City of Oakland
Landmarks Preservation Advisory Board

REPORT

Case File Number: DV06464-R01

Location:	510-514 7 th Street (also listed under 707 Washington Street)
Parcel Number:	001 -0203-020-00
Proposal:	New construction on vacant parcel in Old Oakland for a 5-story mixed use project with 24 residential units, ground floor retail space, ground floor parking, and rooftop open space
Owner:	Steven Ho
Applicant:	Derek Chau
Planning Permits Required:	Major Regular Design Review
General Plan:	Central Business District
Zoning:	CBD-P Central Business District Pedestrian Retail Commercial Zone, S-7 Preservation Combining Zone, S-17 Downtown Residential Open Space Combining Zone
Environmental Determination:	Exempt per CEQA Guidelines Categorical Exemption Section 15332 – Infill Development Projects, and Section 15183, Projects Consistent with a Community Plan, General Plan, or Zoning
Historic Status:	Vacant Lot located in Old Oakland (API), S-7 district
City Council District:	3
Action to be Taken:	Informational presentation on status update to the Landmarks Board of previously approved project

1 WASHINGTON ELEVATION
 A.6 Scale: 1/4" = 1'-0"

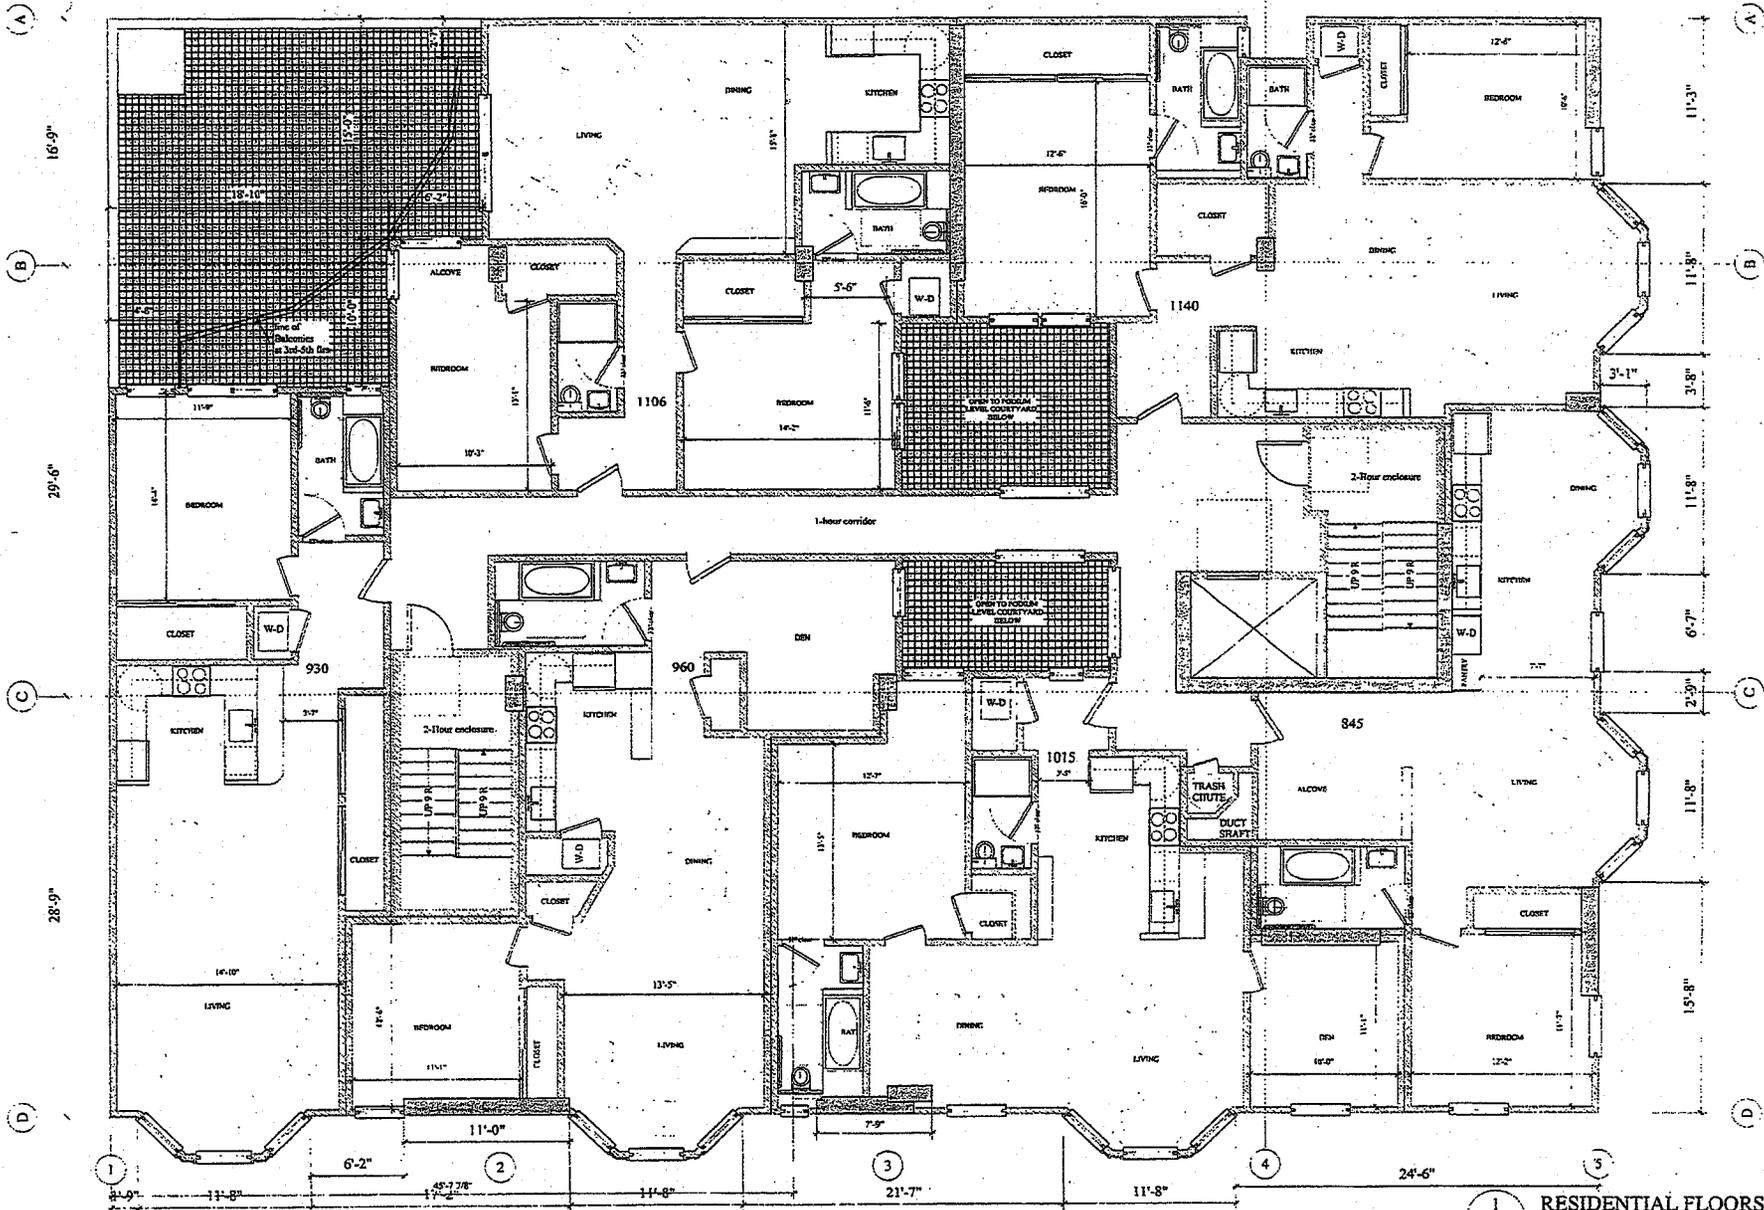
Staff's only further comment on the design is the corner bay storefront along Washington, where there is a combination of glazing and tile in the recessed storefront area. Staff has recommended that this be modified to match the corner bay along 7th Street, where there is a base tile bulkhead, with a storefront display window and transom above. The applicant is checking with his structural engineer regarding lateral bracing to determine if this could be modified or relocated.

1 Side Elevation
Scale: 1/8" = 1'-0"

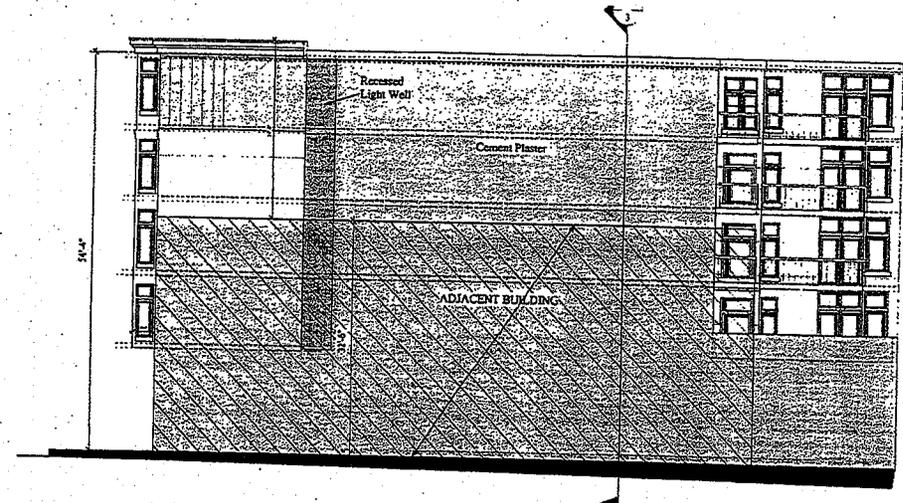
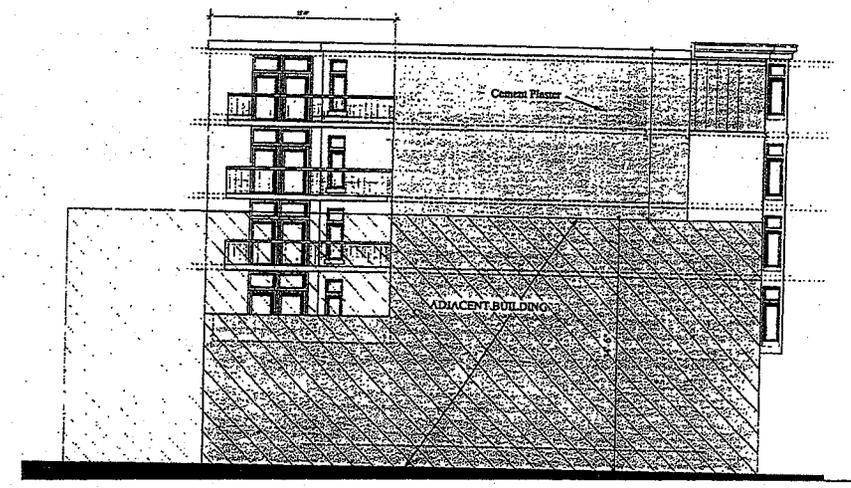
- contributor to the Historic District.
- Color and Materials Board: Review and make recommendations on color, tile quality, etc.
- Projecting bays along 7th Street: Although currently there are not any projecting bays along 7th Street, there is historic precedence for projecting bays along this corridor (see attached rendering from the Historic Resources Inventory.) Also, the projecting bays are integral to the design concept, and strengthen and define this edge of the Historic District as part of the Old Oakland District.
